MEETING:	REGULAR MEETING OF THE PLAN COMMISSION
DATE & TIME:	Monday, February 10, 2025 at 6:30 PM
LOCATION:	Germantown Village Hall Board Room N112 W17001 Mequon Road

FOLLOWED BY A 10-MINUTE RECESS
 - B. Capstone Development Company, Agent for CQ WI 2021, LLC Property Owner - N128 W20833 Holy Hill Road. Site Development and Building Plan Review for a 291,140 sqft Industrial/Warehousing Building in the Capstone 41 Business Park - Phase 3 (ACTION)

CAPSTONE 41 - PHASE III
PROJECT NUMBER: 079.22.121

THESE PLANS AND DESIGNS ARE COPYRIGHT PROTECTED AND MAY NOT BE USED IN WHOLE OR IN PART WITHOUT THE WRITTEN CONSENT OF PINNACLE ENGINEERING GROUP, LLC
DESIGNED: ADH
DRAWN: ADH
CHECKED: TOM
REVIEWED: TOM

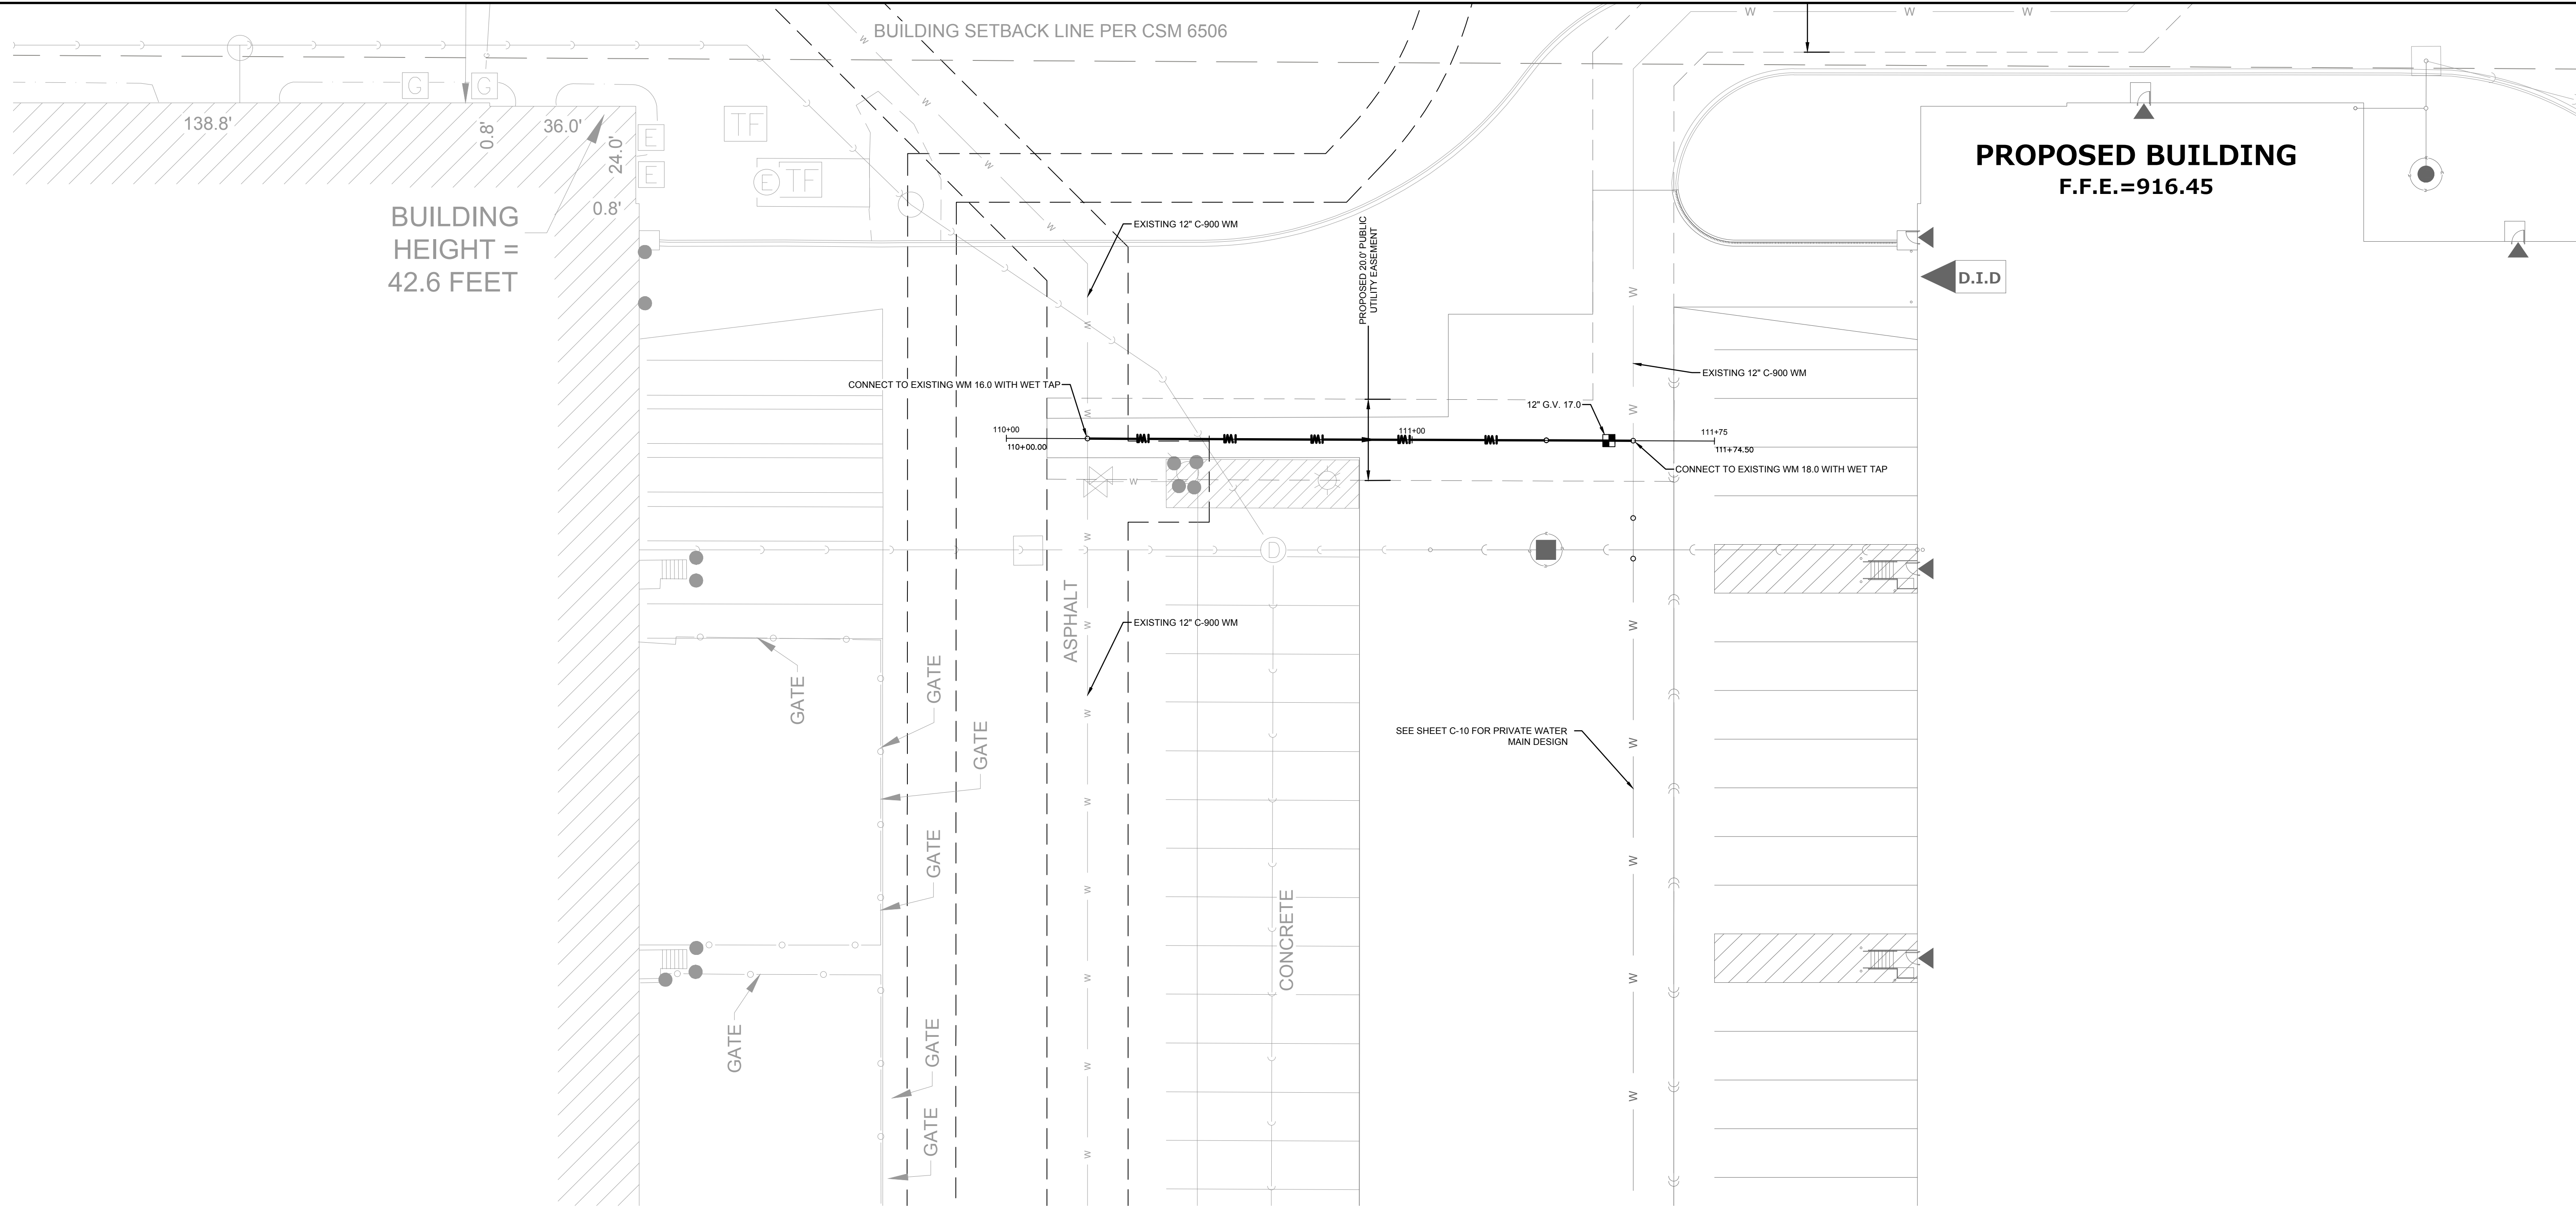
1. Crossings on Sheet C-10, Index of crossings is provided, however the corresponding call-outs for respective locations is missing. Update crossings with call-out corresponding locations.

2. Lateral on Sheets C-10 & C-11, connection lateral to mainline. Sample manhole is required. Per Village of Germantown Development Handbook, (3.1.6.2.5), Lateral connections to manholes shall not be made unless pre-approved by the Wastewater Superintendent. Connections to manholes in new construction shall not be above the outlet sewer crown and have a smooth paved channel constructed to convey lateral waste to main outlet channel.
3. Lateral on Sheet C-11, Contractor to provide submittals for water tight connection consistent with requirements in Development Handbook.
4. Sanitary Submittals to be transmitted to Wastewater Utility Superintendent and Village Engineer for review prior to the pre-construction meeting.

- Sheet C-9 - Tracer Wire – Note #17 Tracer wire references state statute but does not refer to Village of Germantown Development Handbook. Revise to reference compliance with Section 2.1.11 of the Villages standards where Open Cut tracer wire will be Copperhead #1230-HS-30mil.

- Sheet C-9 - Tracer Wire – Note #15, the tracer wire section is an incorrect call out, remove #10 solid and use #12 solid wire.
- Sheet C-11, At the connection point from Ph III to Ph II. Remove and salvage existing hydrant. Install new hydrant. Contact Water Utility for salvaging hydrant.
